# UNITED STATES PATENT AND TRADEMARK OFFICE

APPLICATION NO.	FILING DATE	FIRST NAMED INVENTOR	ATTORNEY DOCKET NO.	CONFIRMATION NO.
10/550,186	05/25/2006	Heikki Saariluoma	L4325.0002	5317
32172 7590 06/03/2009 DICKSTEIN SHAPIRO LLP 1177 AVENUE OF THE AMERICAS (6TH AVENUE) NEW YORK, NY 10036-2714			EXAMINER LANGDON, EVAN H	
			ART UNIT 3654	PAPER NUMBER
			MAIL DATE 06/03/2009	DELIVERY MODE PAPER

<b>Office Action Summary</b>	<b>Application No.</b> 10/550,186	<b>Applicant(s)</b> SAARILUOMA ET AL.	
	<b>Examiner</b> EVAN H. LANGDON	<b>Art Unit</b> 3654

## **DETAILED ACTION**

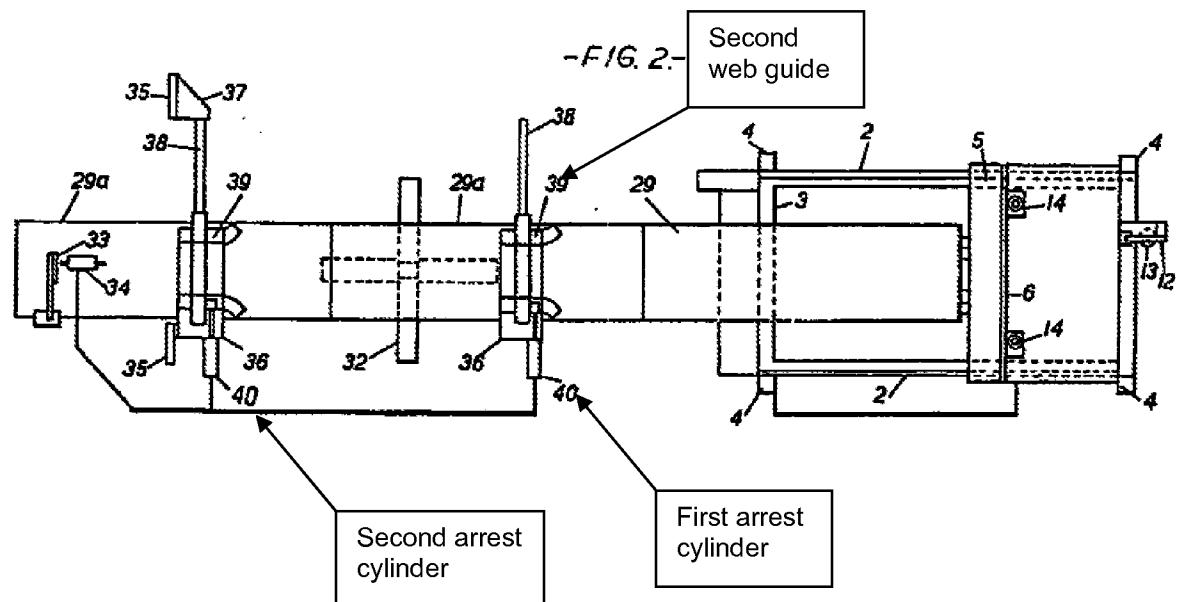
Marshall discloses a feed mechanism for feeding a material to be processed into a working assembly included in a sheet processing line, the working assembly having an entry side, an exit side and an entry track (5), the feed mechanism comprising

at least one first web guide (20) provided on the entry side of the working assembly on either side of the entry track (29) for guiding sides (Fig. 3) of the strip which are parallel to the entry track (29), such that at least one of the web guides (20) present on the opposite sides of the strip is equipped with a positioning element (adjustable means on guide 20) for shifting the strip to a desired position in a direction crosswise to the entry track's (29) lengthwise direction,

a first feeder (1), provided on the working assembly's entry side and shutting co-directionally with the entry track (29), which is equipped with grippers (19) taking hold of the opposite sides of the strip and being adapted to move by one or more positioning elements for shifting the strip to a desired position in a direction crosswise to the direction of the entry track,

a barrier (35) for determining the position for a leading edge of the strip

the first feeder for bringing the leading edge of the strip against the barrier (35),

at least one first arrest cylinder (40, see annotated Fig. 2 below) provided on the working assembly's entry side for immobilizing the subsequently processed strip relative to the entry track (29),

at least one second web guide (39) provided on either side of the entry track (29) on the working assembly's exit side for guiding the sides of the strip which are parallel to the entry track (29), such that at least one of the web guides (39) present on the opposite sides of the strip is equipped with a positioning element (39) for shifting the

a second feeder (39), provided on the working assembly's exit side and adapted to shuttle parallel to the entry track (29), which is equipped with a gripper (39) taking hold of the side edge (39) of the strip the gripper being adapted to travel in a direction crosswise to the direction of the entry track (29), and

at least one second arrest cylinder (40) provided on the working assembly's exit side for immobilizing the processed strip relative to the entry track (29).
